14 CFR Part 39

[Docket No. 2003-SW-10-AD; Amendment 39-14621; AD 2003-21-09 R1]

Airworthiness Directives; Eurocopter France Model AS355E, F, F1, F2, and N Helicopters

ACTION: Final rule.

Figure 1

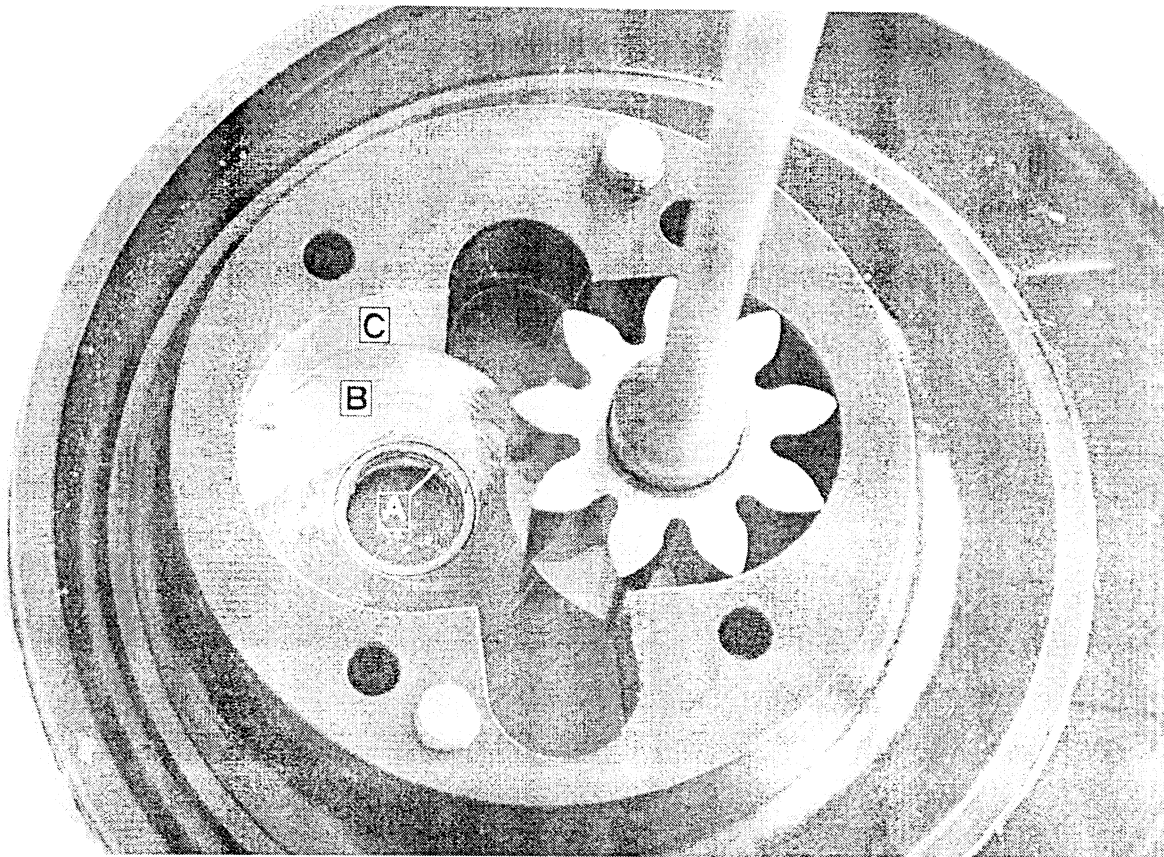
(d) While inspecting the pump, if you find any of the following, replace the MGB and the pump with an airworthy MGB and pump before further flight:

- (1) Crank pin play,
- (2) Out of round bronze bushing (A of Figure 1),
- (3) Offset of the driven gear pinion,
- (4) Metal chips, or
- (5) Wear (C of Figure 1).

Note 2: If wear is present in the B area only as depicted in Figure 1, replacing the MGB and the pump is not required.
